Polk County Zoning Commission
Monday, November 22, 2021
Staff Report

Ironwood Heights – Major Preliminary Plat

Preliminary Plat approval of a Major Subdivision Plat creating 16 new single-family residential lots

**CUL-DE-SAC: TYPICAL & PROFILE
LINE & CURVE DATA**

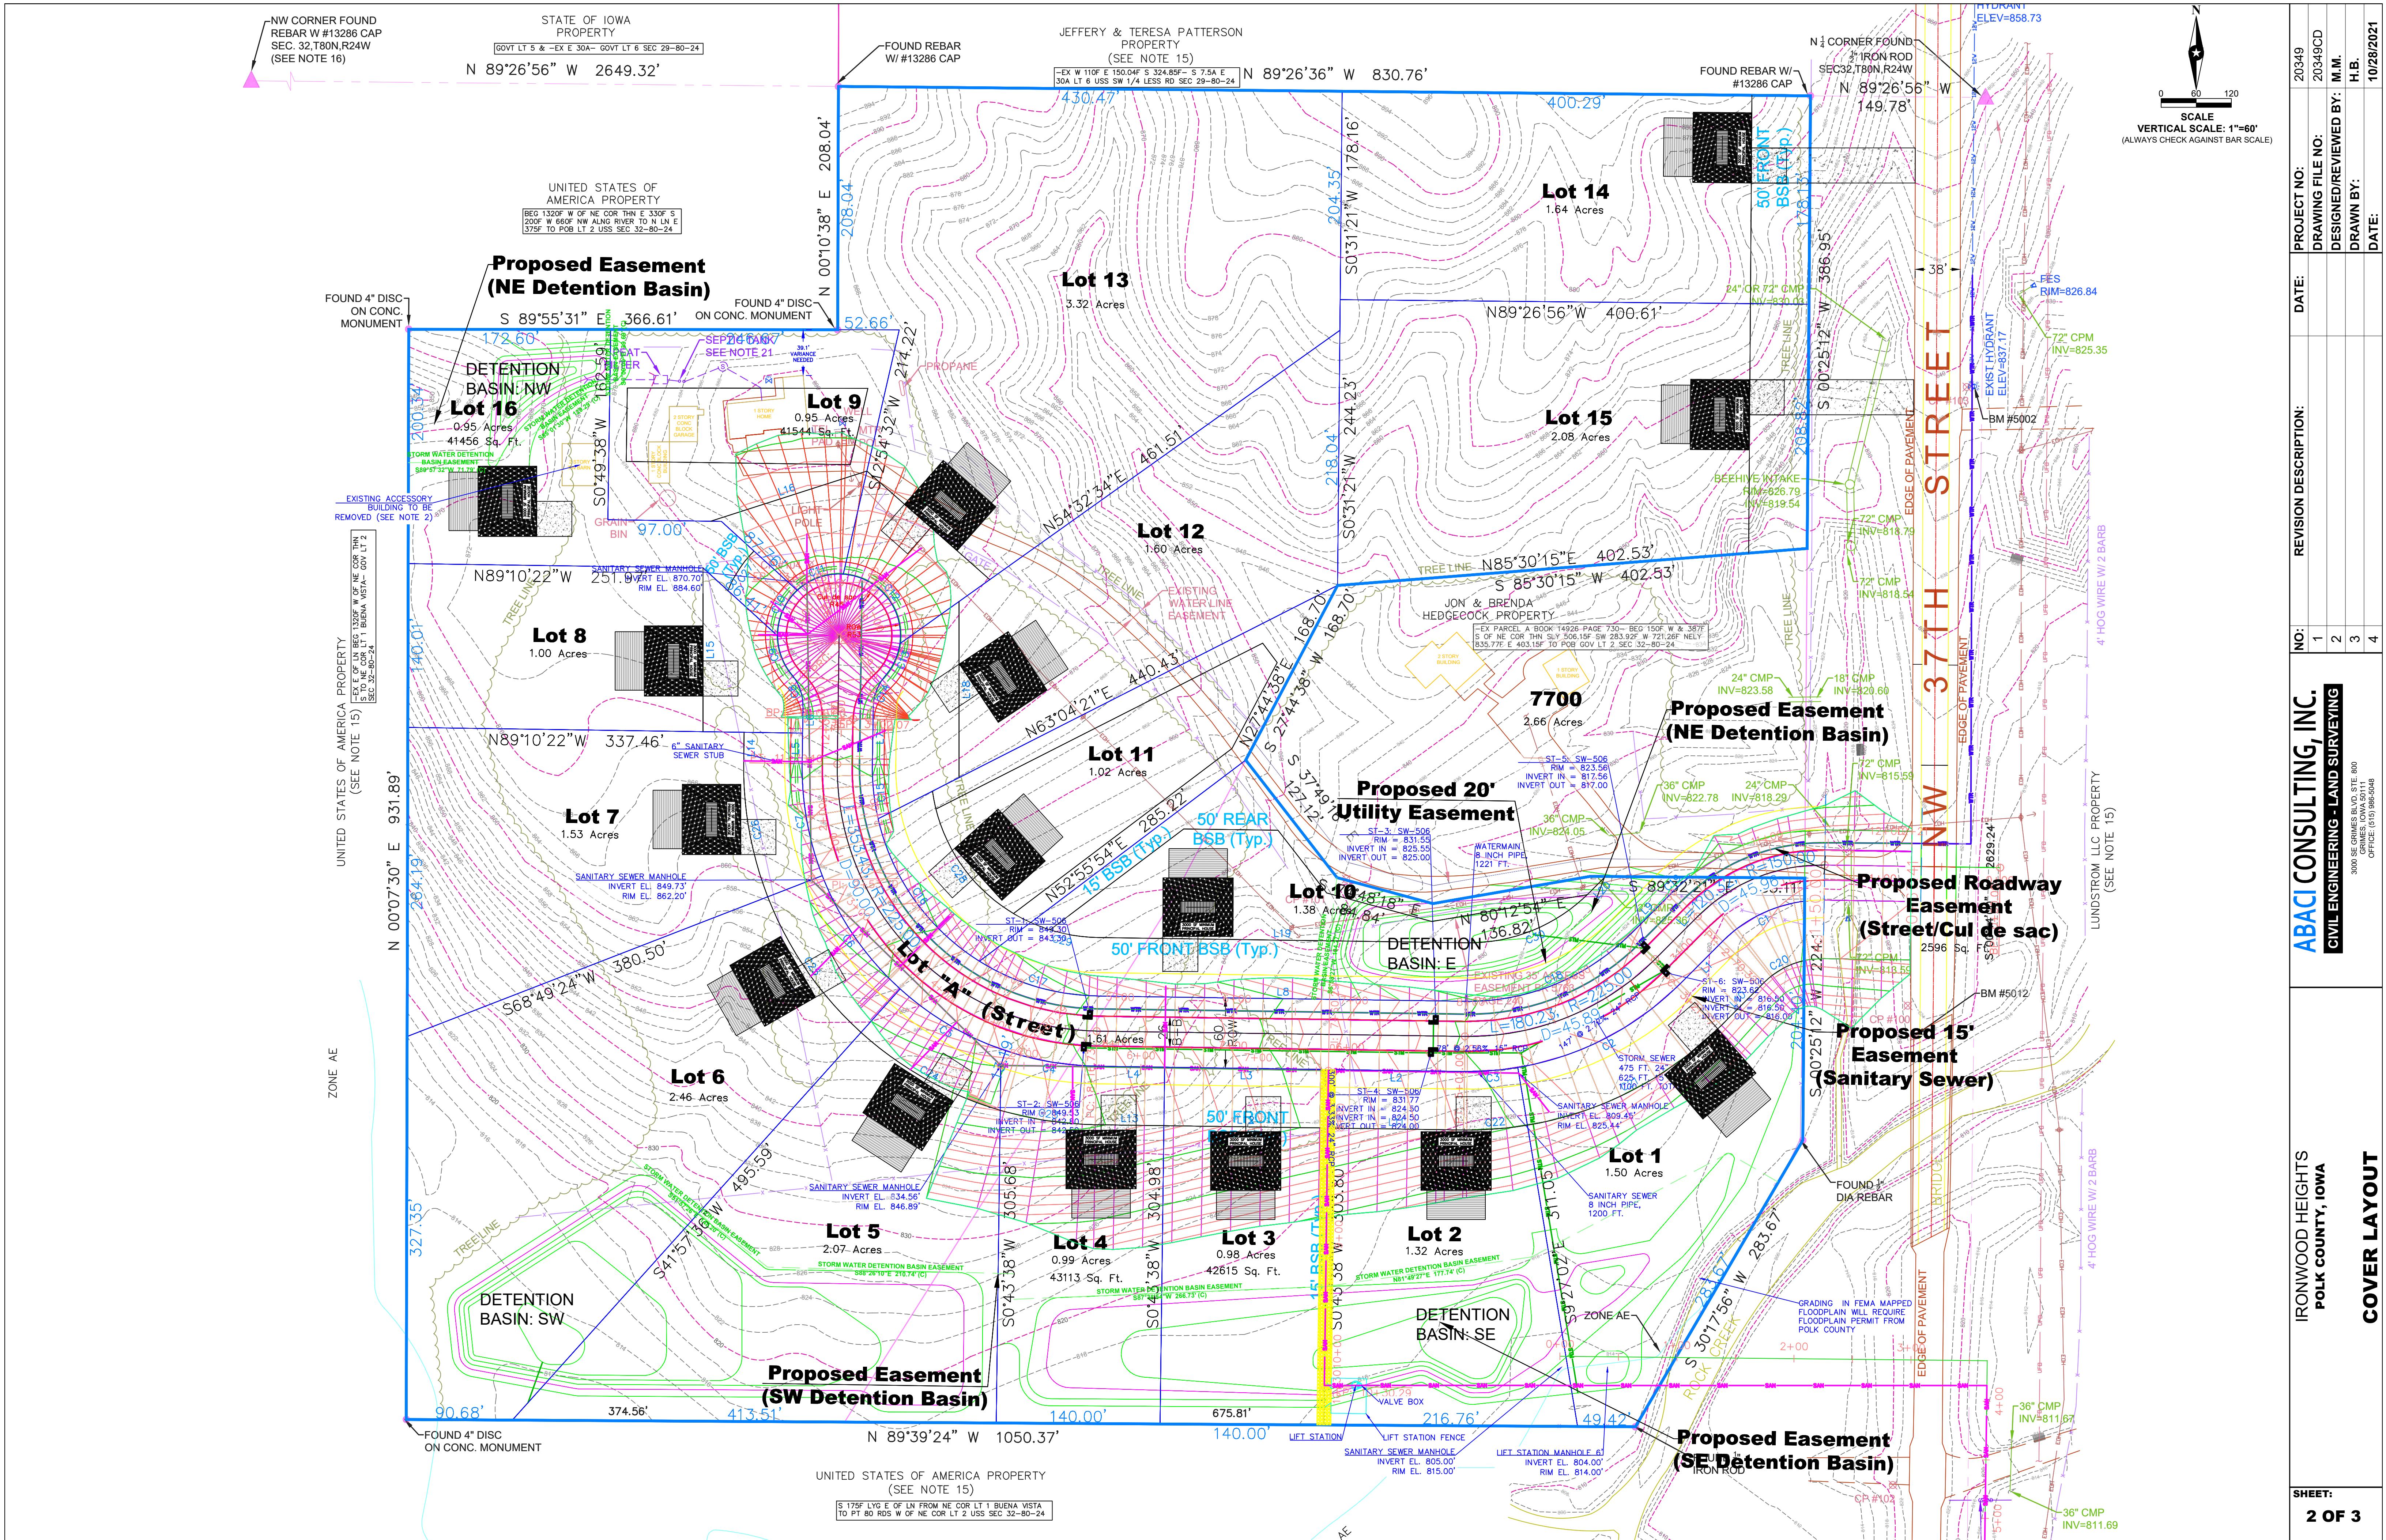
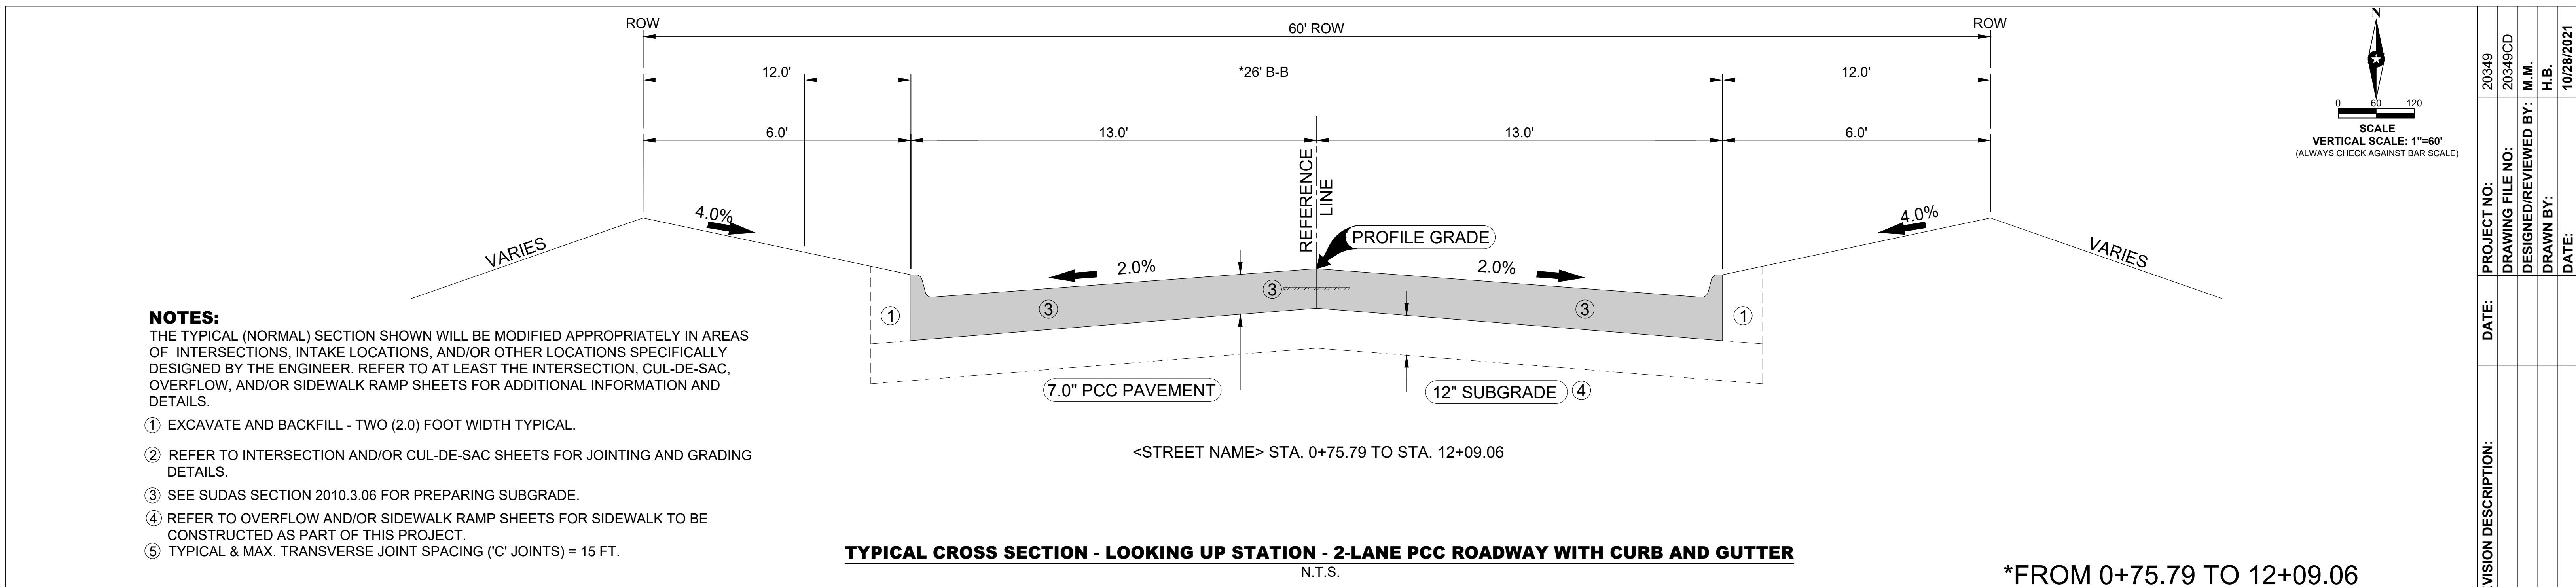
In response to the received comments, and as an attachment to the Preliminary Plat Planset of Ironwood Heights, this is a request for a waiver to the cul-de-sac length.

The Polk County Subdivision Ordinance (Article 5: Subdivision Plat Design Standards, Section 7(B)(1) page 28) states that a cul-de-sac can be “no longer than 600 feet from adjacent right of way to the end of the proposed right of way in Residential Developments.”

The proposed cul-de-sac length is 1,258 feet, which includes the intersection length off NW 37th Street as well as the entire length of the bulb at the end of the cul-de-sac. From that point, there is 18 feet to the right of way, bringing the total to 1,278 feet.

The length waiver is required in order to fully develop the parcel per the Land Use Plan and Zoning designation. This parcel is enveloped on the south, west and northwest by United States of America owned land that is part of Saylorville Reservoir. Additionally, the land directly to the north has been developed and then has USA land adjacent on its north side. As such, it is not feasible to extend a street across this property to the south, west, or north. Without the length waiver, the codified limitations on flagpole length would prevent the full development of this property.

The cul-de-sac design length was also increased to overcome the large elevation difference from the lowest point on the cul-de-sac to the highest while maintaining a maximum longitudinal slope of 6%. Had the cul-de-sac been designed any shorter, the slope would need to exceed the specified non-negotiable maximum of 6%.

Staff recommends approval of the Preliminary Plat of Ironwood Heights, as well as the requested waiver to the cul-de-sac length. Staff is supportive of the waiver due to the site topography and lack of development potential of adjacent properties, as surrounding ground is primarily held in public ownership and contains floodplain and natural features including steep topography, Rock
